Area Walk-By Checklist (AWC)

Location (Bldg, Elev, Room/Area): Area Walk-by 4-17

Peer Review Report
for
Near Term Task Force (NTTF) Recommendation 2.3
Seismic Walkdown Inspection
of
LaSalle County Generating Station Unit 1

20120917-Lasalle 340

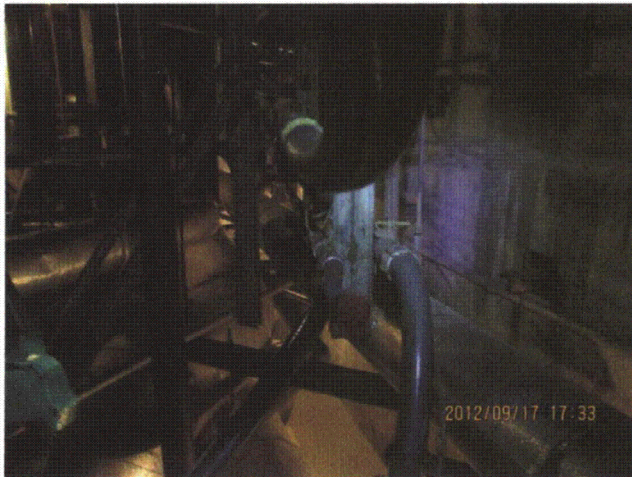
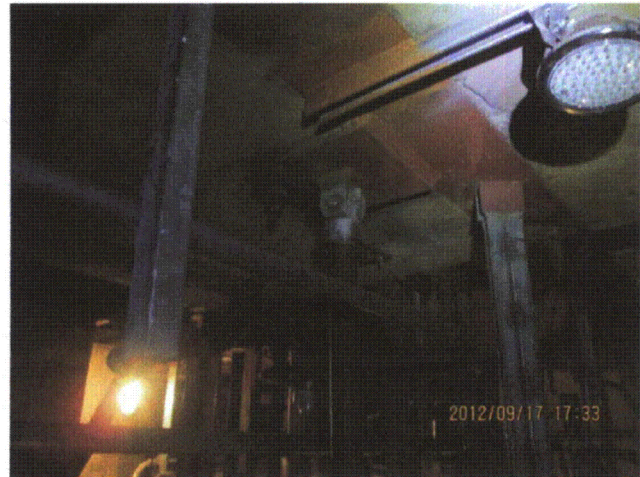
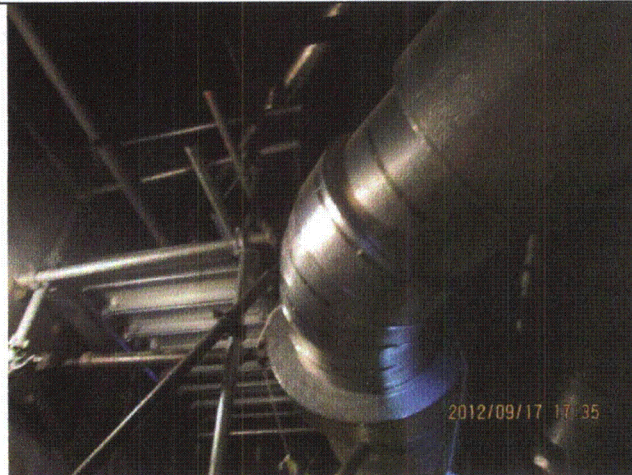
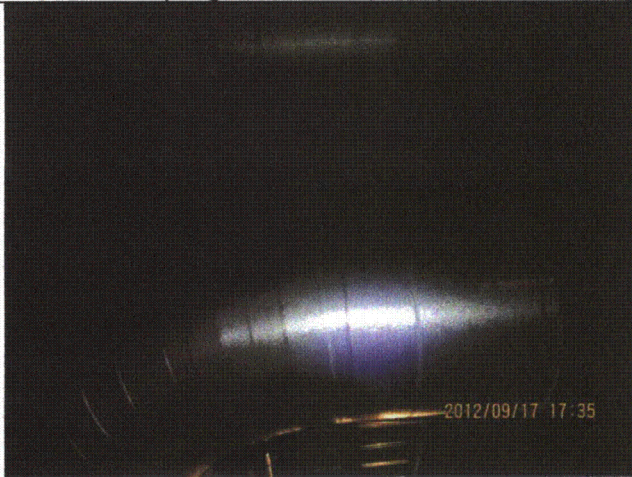
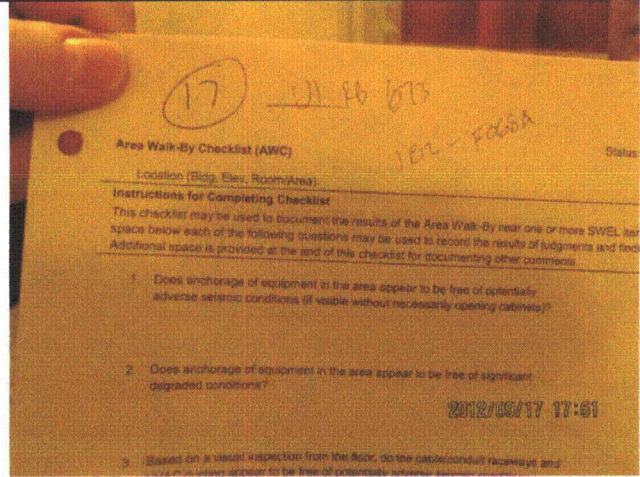
2. Does anchorage of equipment in the area appear to be free of significant degraded conditions? Yes
More than minor corrosion of auxiliary steel base plates beneath valve 1E12-F068A due to leakage. Scale only; no separation of material observed. Judged to be acceptable. Station is aware of leak per WO 01432087.

7. Does it appear that the area is free of potentially adverse seismic interactions associated with housekeeping practices, storage of portable equipment, and temporary installations (e.g., scaffolding, lead shielding)? Yes
More than minor corrosion of lower scaffold legs beneath valve 1E12-F068A due to leakage. Scale only; no separation of material observed. Judged to be acceptable. Per Operations, station is aware of leak.

8. Have you looked for and found no other seismic conditions that could adversely affect the safety functions of the equipment in the area? Yes
More than minor corrosion of auxiliary steel beneath valve 1E12-F068A due to leakage. Scale only; no separation of material observed. Judged to be acceptable. Per Operations, station is aware of leak.

20120917-Lasalle 359

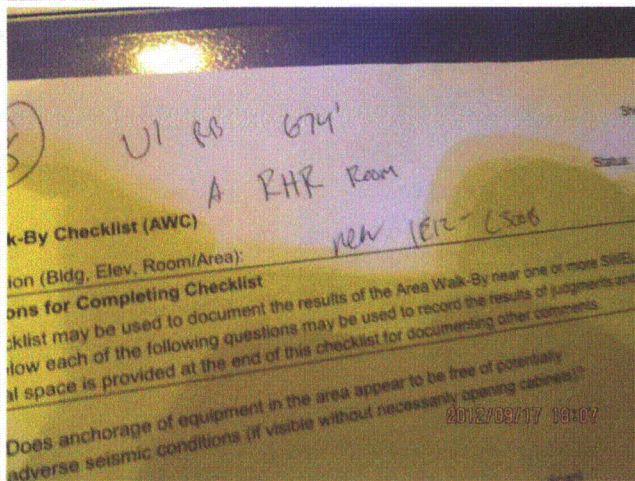
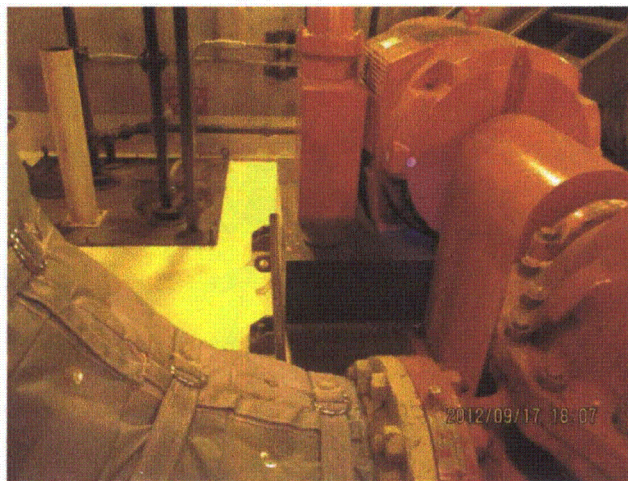
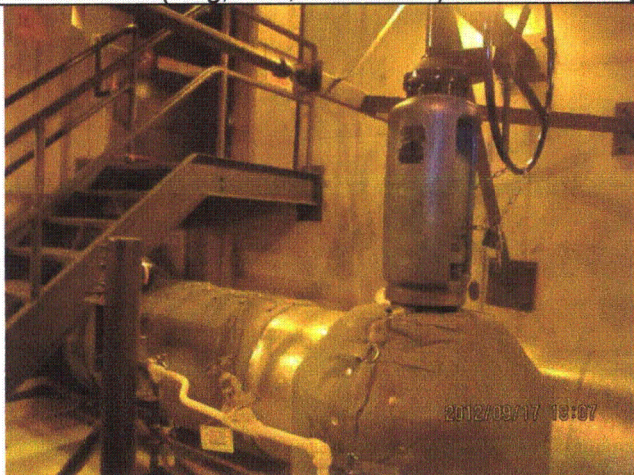
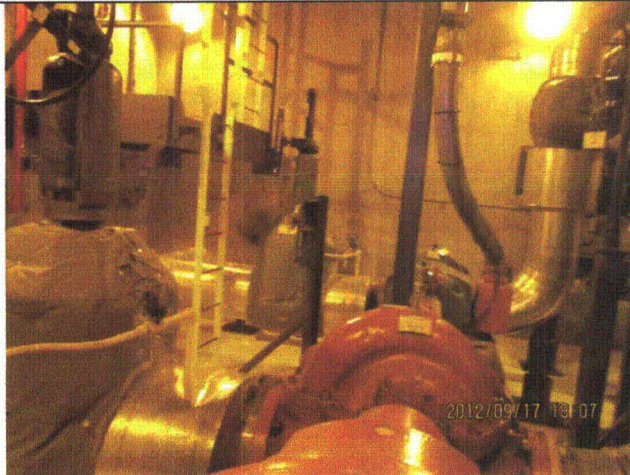
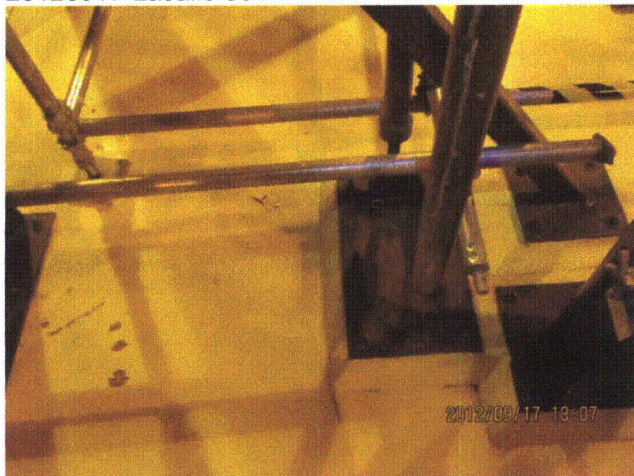
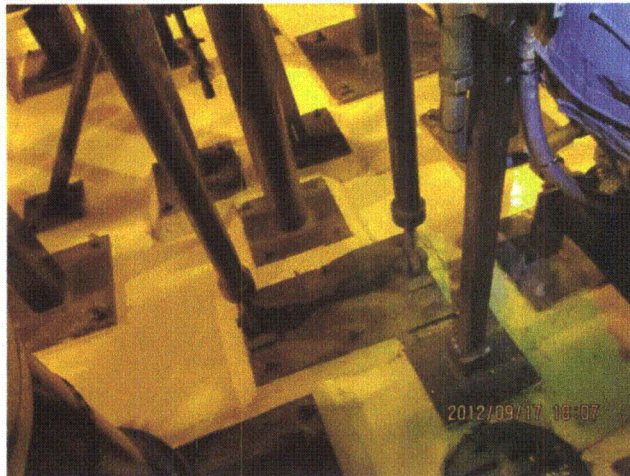
2. Does anchorage of equipment in the area appear to be free of significant degraded conditions? Yes
Minor corrosion in several base plates judged to be acceptable.

4. Does it appear that the area is free of potentially adverse seismic spatial interactions with other equipment in the area (e.g., ceiling tiles and lighting)? Yes
Insulated, non-safety-related pipes in contact. Judged to be acceptable.

5. Does it appear that the area is free of potentially adverse seismic interactions that could cause flooding or spray in the area? Yes
Deluge system with threaded pipe is dry; requires signal to activate. Judged to be acceptable. Remaining piping is welded and judged to be acceptable.

7. Does it appear that the area is free of potentially adverse seismic interactions associated with housekeeping practices, storage of portable equipment, and temporary installations (e.g., scaffolding, lead shielding)? Yes
Scaffold adequately restrained to auxiliary steel.

20120918-Lasalle 039

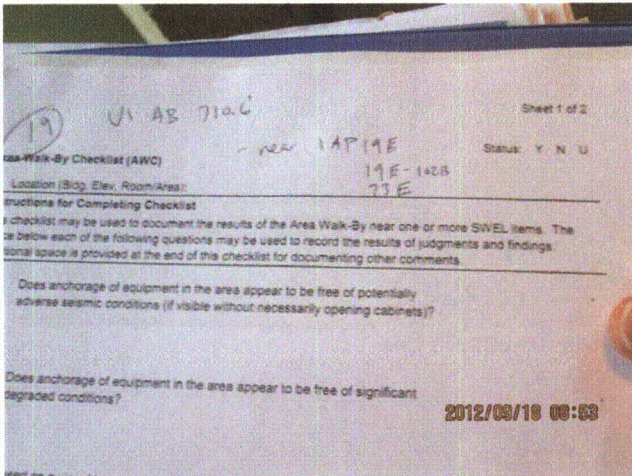
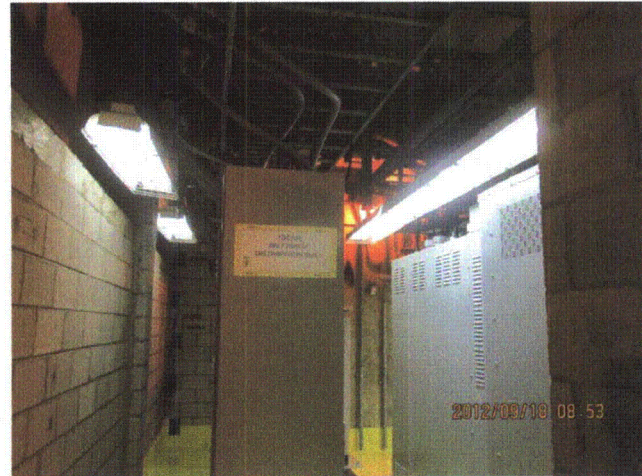
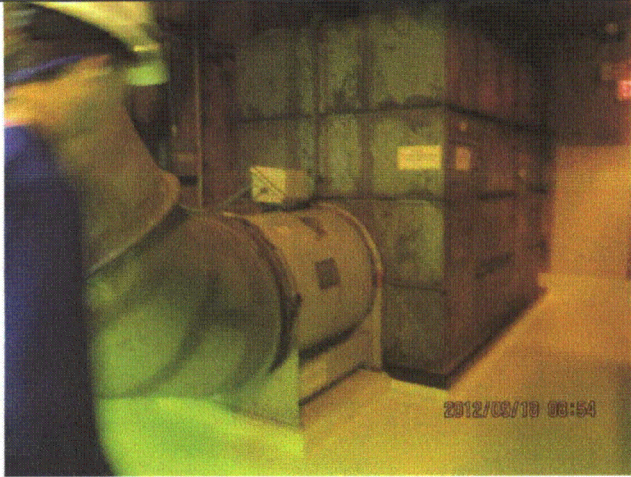
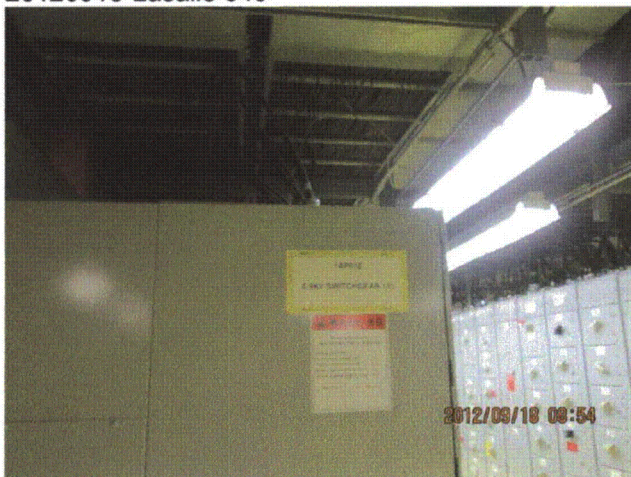
4. Does it appear that the area is free of potentially adverse seismic spatial interactions with other equipment in the area (e.g., ceiling tiles and lighting)? Yes
Overhead chain-hung light fixture prevented from interaction with transformer by short hanging chain, conduit, and chain restraint.

7. Does it appear that the area is free of potentially adverse seismic interactions associated with housekeeping practices, storage of portable equipment, and temporary installations (e.g., scaffolding, lead shielding)? Yes
Wheeled breakers adequately restrained to wall.

Eyewash station adequately restrained to column on opposite side of 19E transformer.
